SEWAGE DISPOSAL TESTING

MARYLAND STATE DEPARTMENT OF HEALTH

SUBDIVISION Jennings Chapel Woods LOT NO. 2ROAD AND DESCRIPTION Daisy Road

INDICATE NORTH - NAML ADJOINING ROADWAY AS BASE LINE.  
*Future Widening Area!*

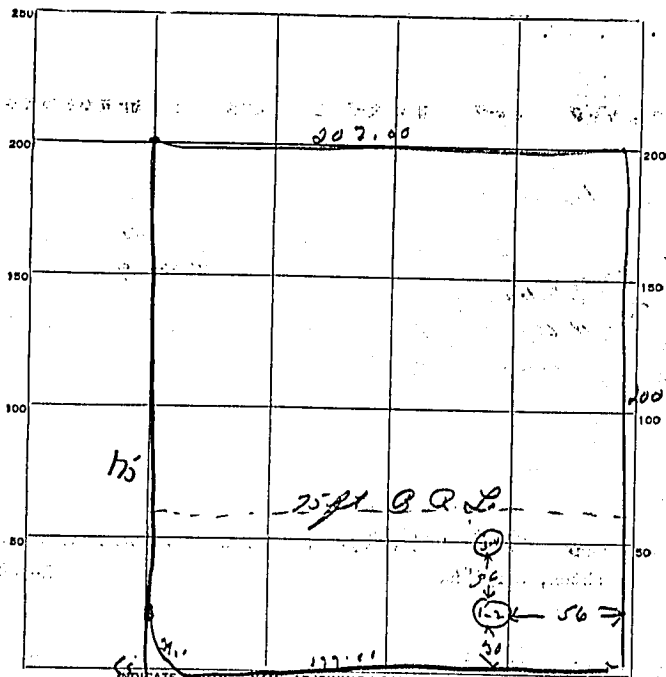
Dry Well - 100 sq. ft. asbestos wall and to begin below inlet pipe  
in bedroom. ~~manhole~~ Inlet pipe at least 4ft below avg. grade. Max depth  
permitted for dry well below avg. grade is 13ft.

Place Dry Well 65 ft from front lot line and 50 ft from right sideline as  
seen when facing lot from Daisy Rd

*Survey OK*
